**Referral 42: VCAT Call-in P508/2024
102-108 Humffray Street South, Bakery Hill
Priority Projects Standing Advisory Committee Report**

Priority Projects Standing Advisory Committee Report pursuant to section 25 of the PE Act

Referral 42: VCAT Call-in P508/2024

102-108 Humffray Street South, Bakery Hill

Figure 12 Corangamite CMA flood information

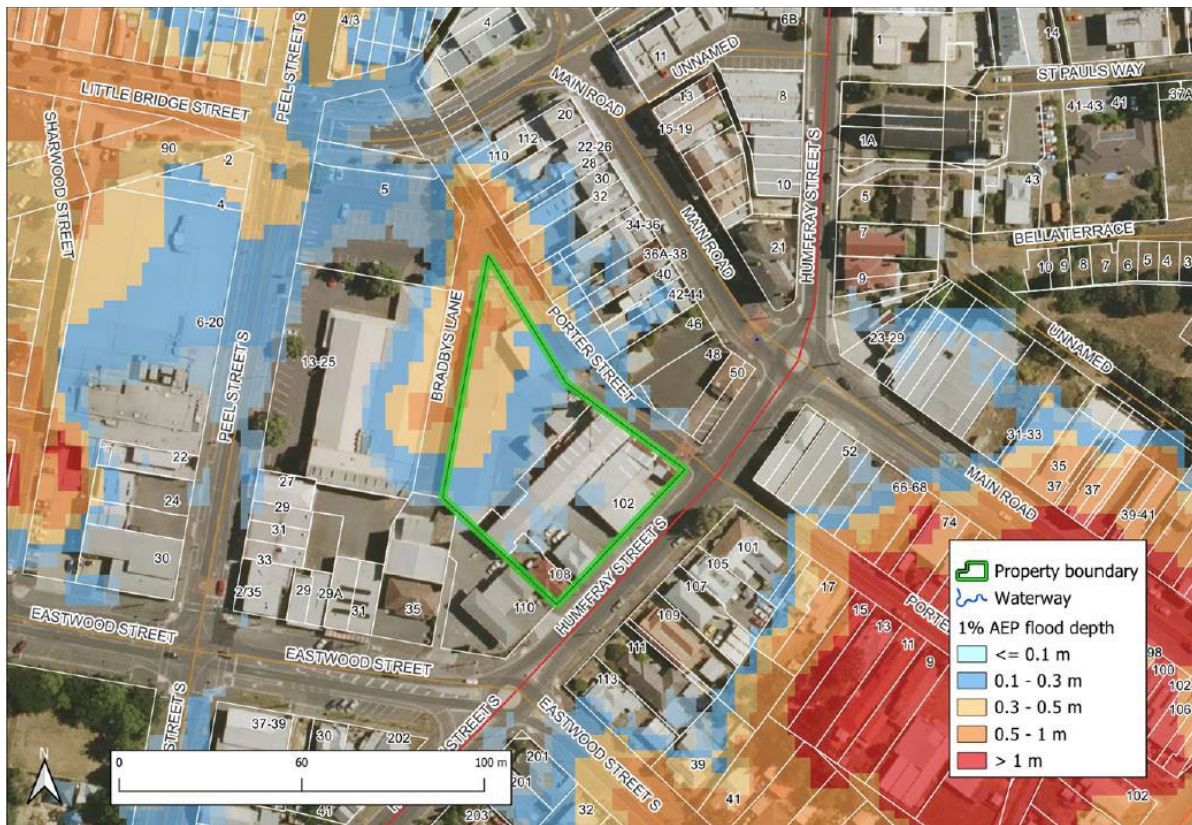
The Corangamite CMA, in response to a section 52 notice of the proposal, objected to the access to the residential building car park off Bradbys Lane due to the depth of flooding being over 300 millimetres. Figure 12 contains the flood mapping from the CMA's online portal that shows the depth of flooding to the rear of the land.

There are no statutory controls that reflect the flooding of the land but the Corangamite CMA-managed online portal shows, in Figure 12, the extent of flooding which is a well-known local constraint.

The NOD addressed this Corangamite CMA response and required amended plans through conditions:

- 1(b) to delete the vehicle access point off Bradbys Lane
- 1(c) to note no access to the residential building off Bradbys Lane

- 1(d) to delete all parking in the residential building.

Figure 13 Access to parking from Porter Street

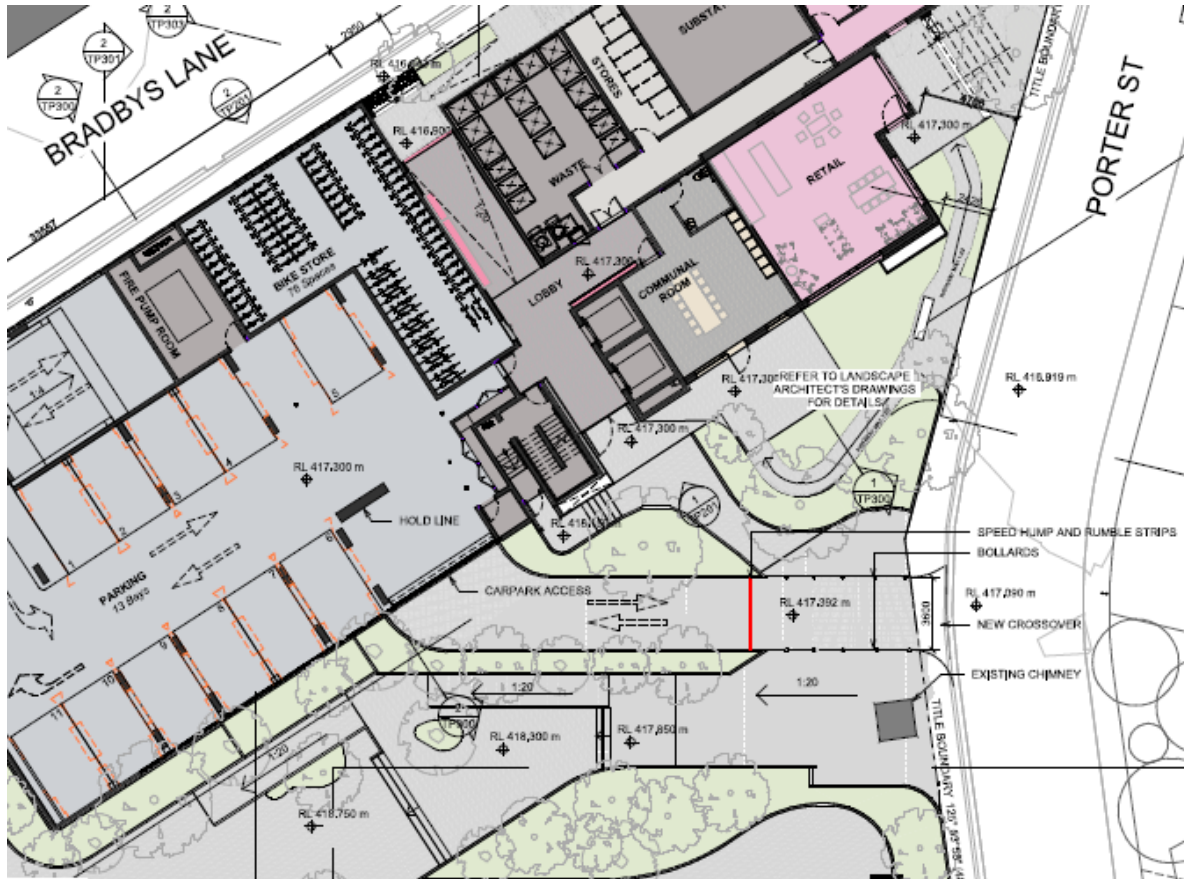
While not a formal position of the Applicant, it prepared Document 17 that showed access across the open space courtyard from Porter Street, which is shown in Figure 13. This alternate access results in the loss of 2 car spaces, leaving a total of 28 spaces.

Figure 13 shows a narrow 3.6 metre wide single lane access across the courtyard next to the old chimney. The Committee considers it is critical this new access is carefully planned and does not detract too much from the role of the courtyard as an open space transition between the two buildings that creates a feature out of the old chimney.

The only other alternative access is therefore across open space courtyard from Porter Street. This is not ideal but presents as the only way for the proposal to move forward. The Committee notes Mr Czarny's concern with this approach but the only other alternative would be to completely review the development concept, an option the Committee contemplated. For reasons set out in this Report, the Committee does not consider the proposal is so flawed that a permit should not issue, and the proposal is an acceptable planning outcome.

- Delete condition 1 (d)
- Add a new condition 1 requirement that provides for the residential building vehicle access off Porter Street.
